UNITED STATES PATENT AND TRADEMARK OFFICE

APPLICATION NO.	FILING DATE	FIRST NAMED INVENTOR	ATTORNEY DOCKET NO.	CONFIRMATION NO.
10/537,436	06/03/2005	Akira Aochi	050323	3190
23850	7590	11/18/2005	EXAMINER	
ARMSTRONG, KRATZ, QUINTOS, HANSON & BROOKS, LLP			NGUYEN, CHAU N	
1725 K STREET, NW			ART UNIT	
SUITE 1000			PAPER NUMBER	
WASHINGTON, DC 20006			2831

Office Action Summary

DETAILED ACTION

【図2】

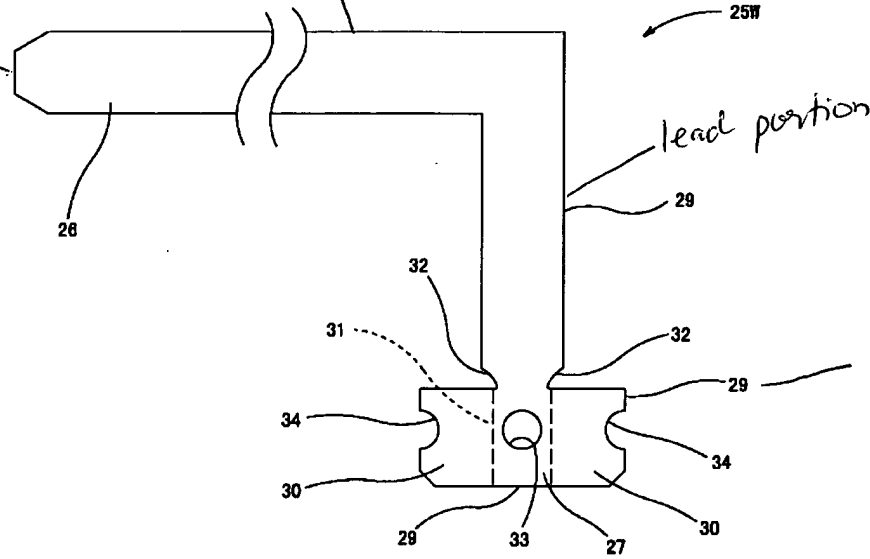
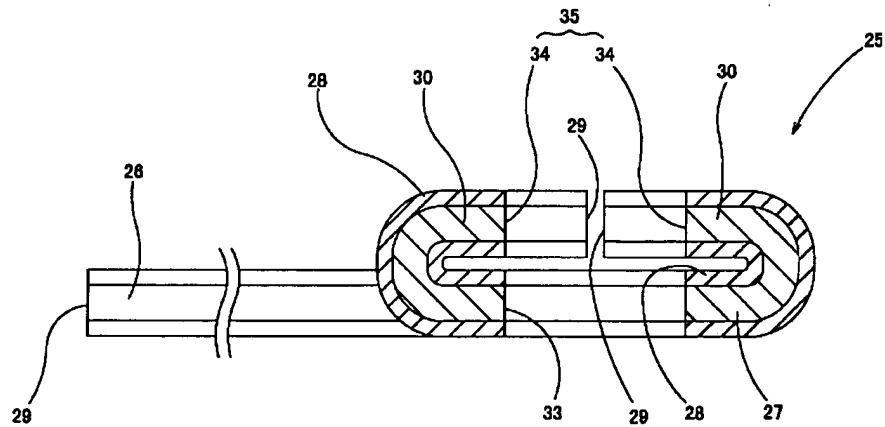
Sawada discloses a circuit board connector (Figures 2-3) comprising a main body portion, a first connecting portion (26), a second connecting portion (25) for connection to a circuit board, wherein the circuit board connector is obtained by cutting a conductive plate material provided with plating layers (28) on front and back sides thereof and thereafter forming the second connection portion into a shape in such a manner that one of the plating layers forms an outer circumferential surface of the second connection portion. Sawada also discloses the cut surfaces at both edges of the second connection portion opposing each other (re claim 2) and a gap is provided between the cut surfaces at both edges of the second connection portion that oppose each other (re claim 3).
